Re: **PETITION NO. 1508 – Enfield Solar One, LLC and VCP, LLC d/b/a Verogy petition for a declaratory ruling, pursuant to Connecticut General Statutes §4-176 and §16-50k, for the proposed construction, maintenance and operation of a 4.0-megawatt AC solar photovoltaic electric generating facility located at 110 North Street, Enfield, Connecticut, and associated electrical interconnection.**

Proposed Facility Changes

PETITION NO. 1508 – ENFIELD SOLAR ONE, LLC

PROPOSED PROJECT CHANGES

Project ENFIELD SOLAR ONE	Sheet CP-1
Date 2/08/2023	
Drawn By BJP

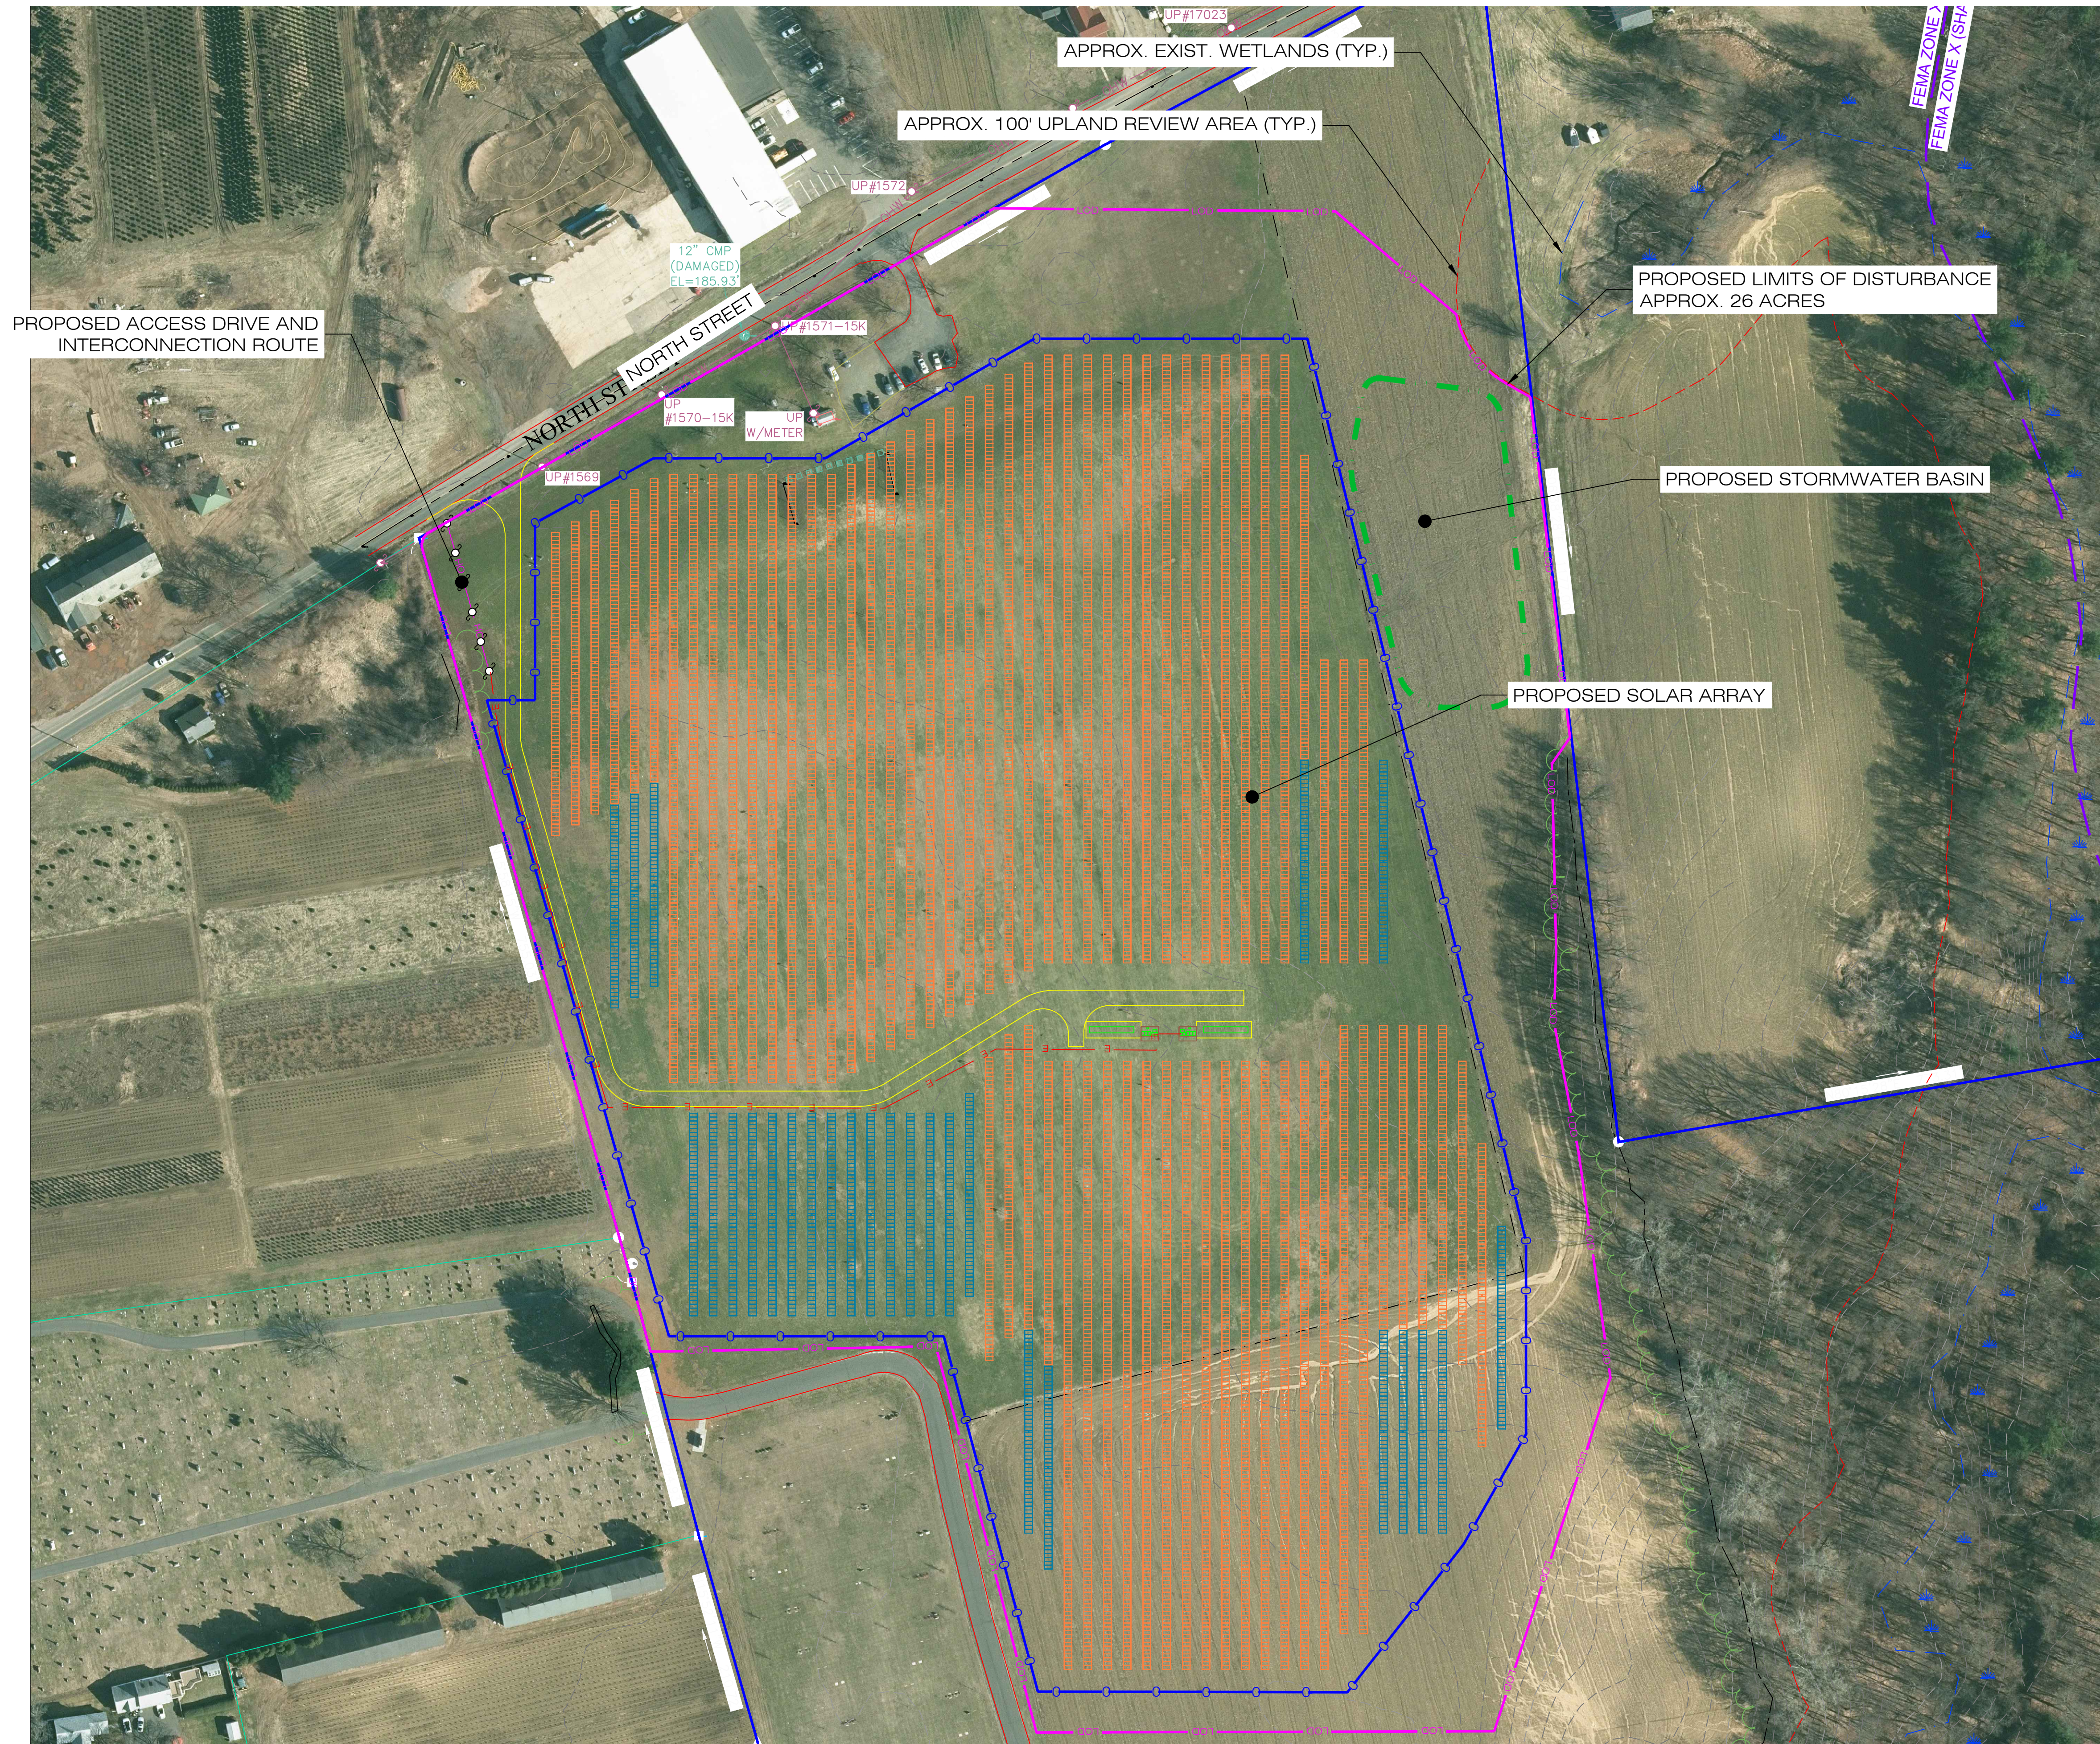
The output capacity of Facility will remain at 4.0 MW AC. However, for the reasons discussed further below, Enfield Solar One is proposing to change the project layout from a fixed tilt racking system to a single-axis tracker racking system. The modified Facility will consist of 10,452, 545-Watt (“W”) PV modules, forty (40) solar inverters, six (6) AC Disconnect Switches and Panel Boards, two (2) 2000 kVA transformers and one (1) electrical service interconnection. See Attachment A for proposed tracker layout.

Utilizing the proposed tracker system also requires the layout of the proposed Facility to change. The northern and western fence lines will remain in approximately the same locations, while the eastern and southern fence lines will be relocated to accommodate the panel layout changes. A majority of the Facility fence line changes occur to the south. The eastern fence will be relocated to approximately the original limits

Project ENFIELD SOLAR ONE	Sheet CP-2
Date 02/08/2023	
Drawn By BJP

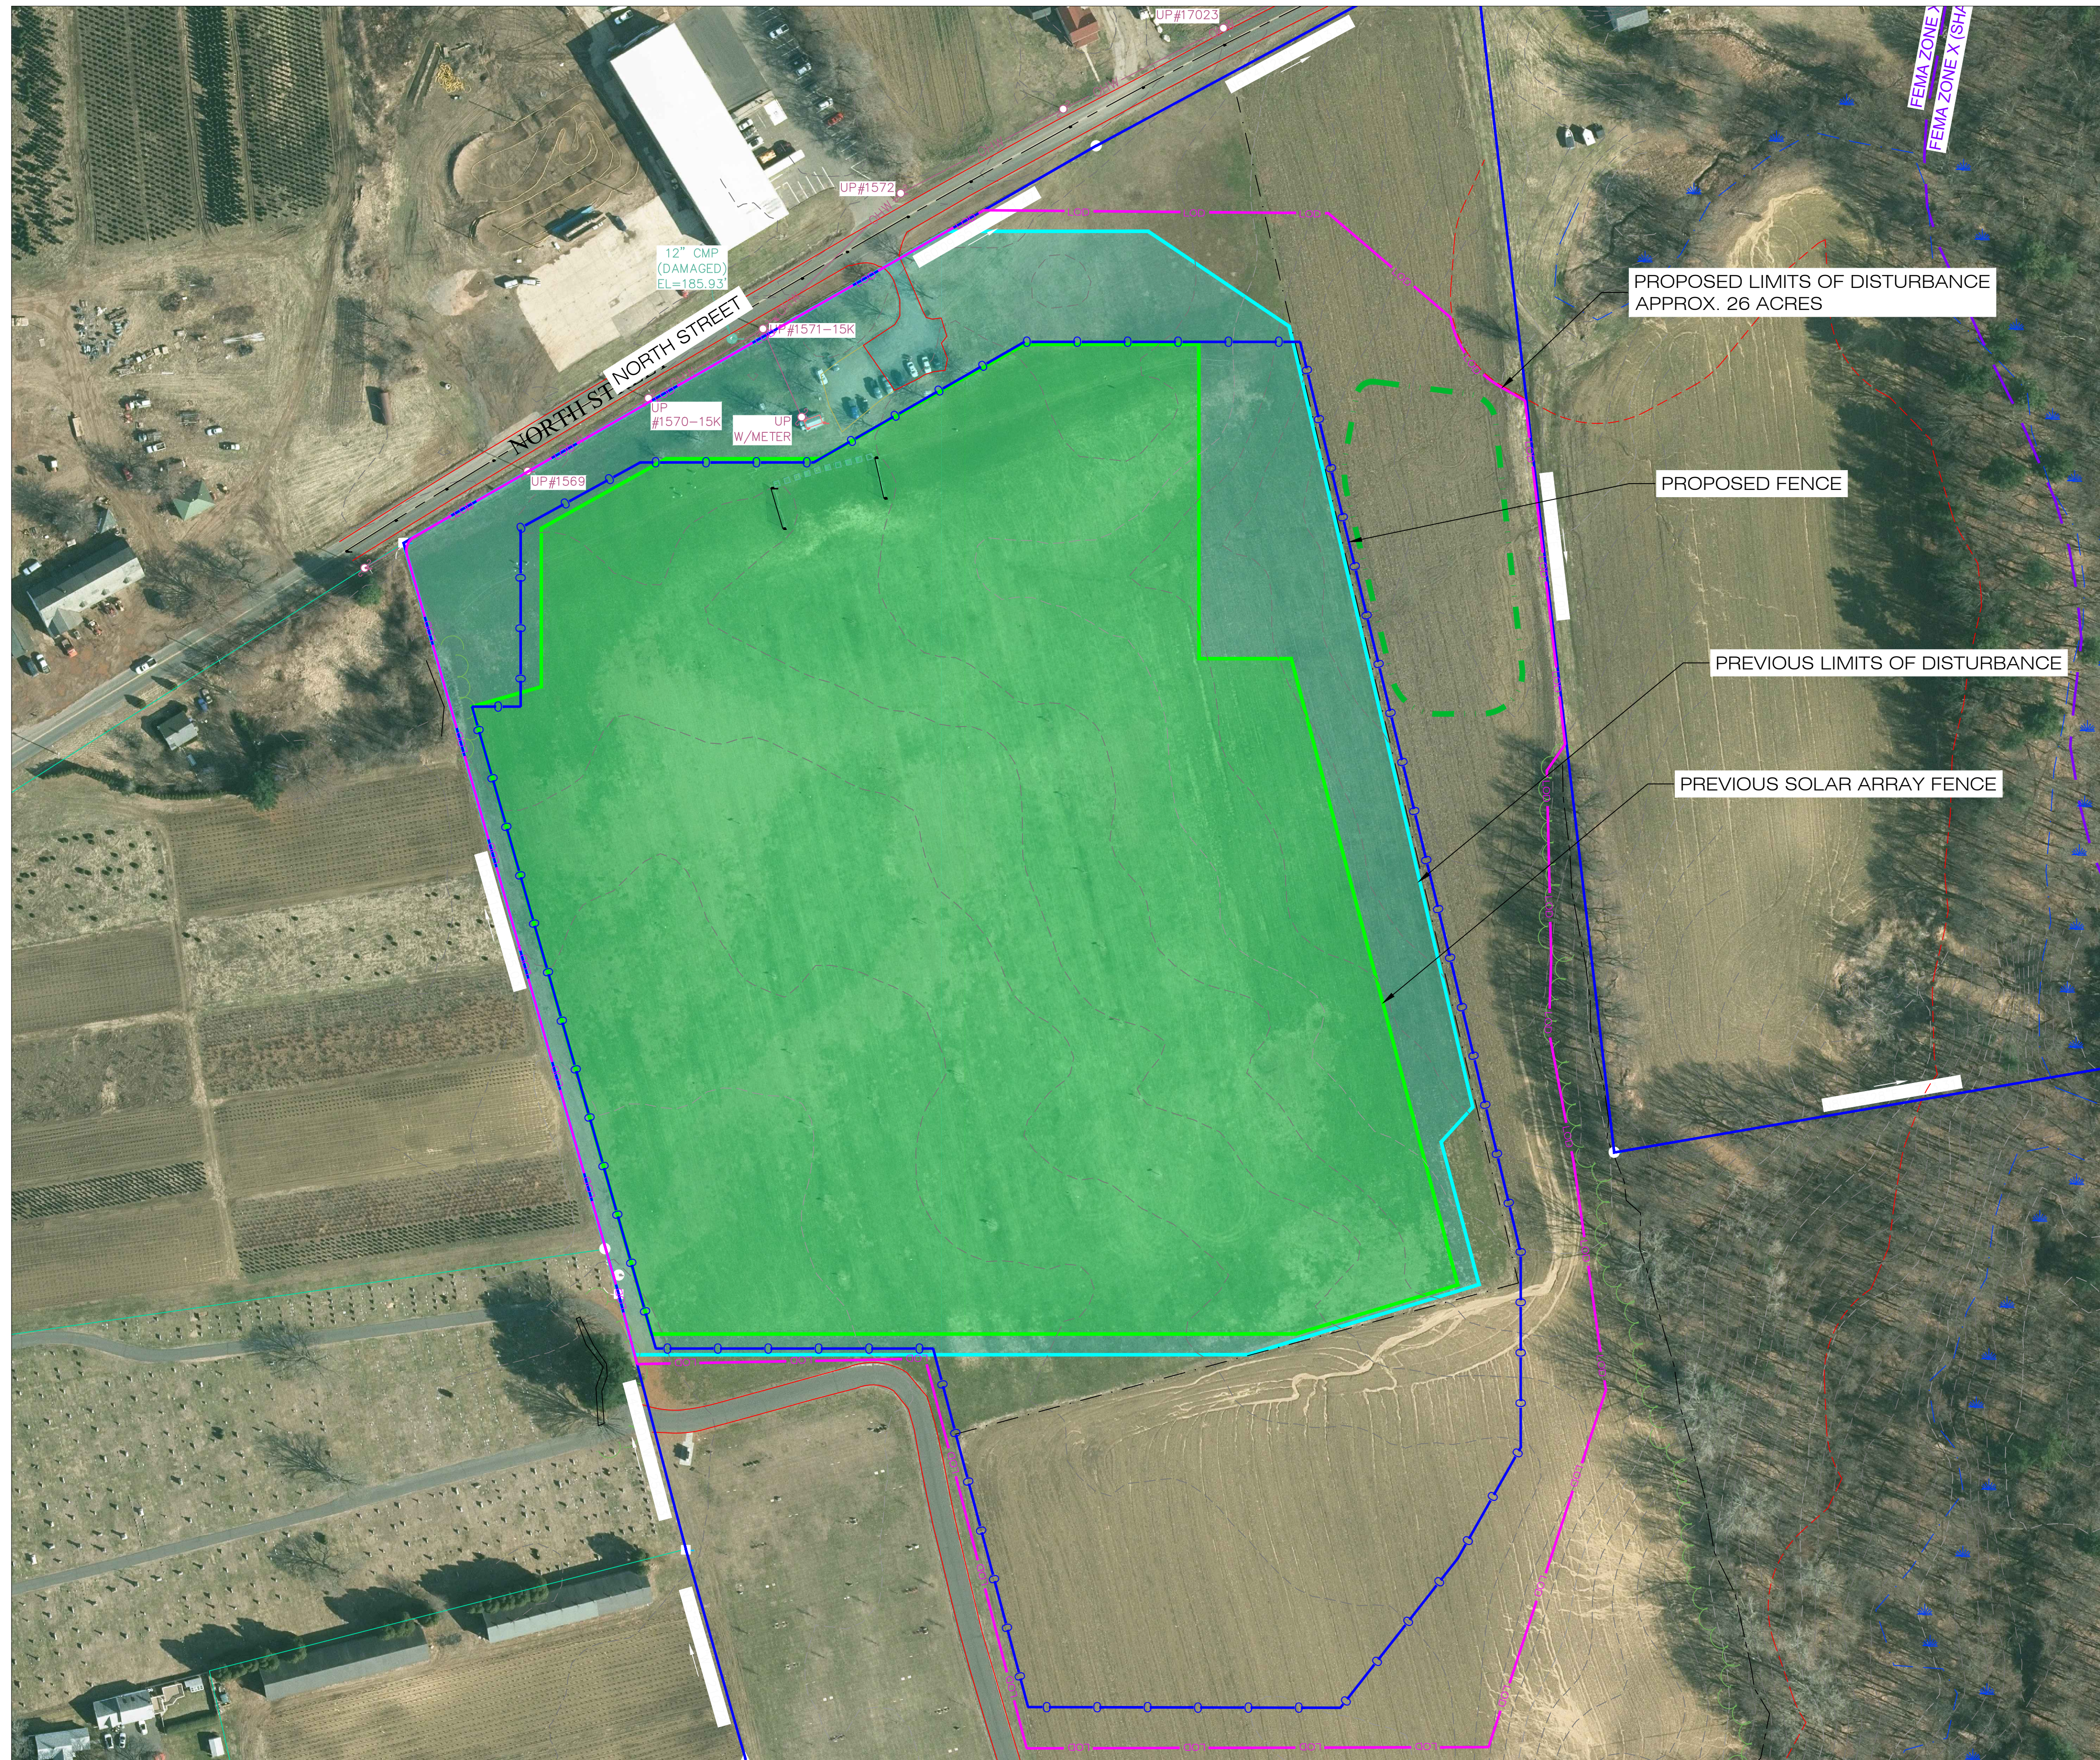
of disturbance (“LOD”) in the eastern portion of the Site. See Attachment D for a comparison of the approved LOD and proposed changes to the LOD and fence lines.

The proposed change results in an overall change of the LOD from approximately 19.6 acres for the approved Facility to approximately 28.57 acres for the modified Facility. The increase to the LOD is necessary to accommodate the increased Facility footprint along with the proposed changes to the soil erosion and sedimentation control measures proposed and the new stormwater management system that are required as a result of the change. The larger LOD remain continue to remain outside the 100-foot buffer to any area wetland. Revised civil site drawing and a new stormwater report both prepared by All-Points Technology Corporation are included as Attachment E.
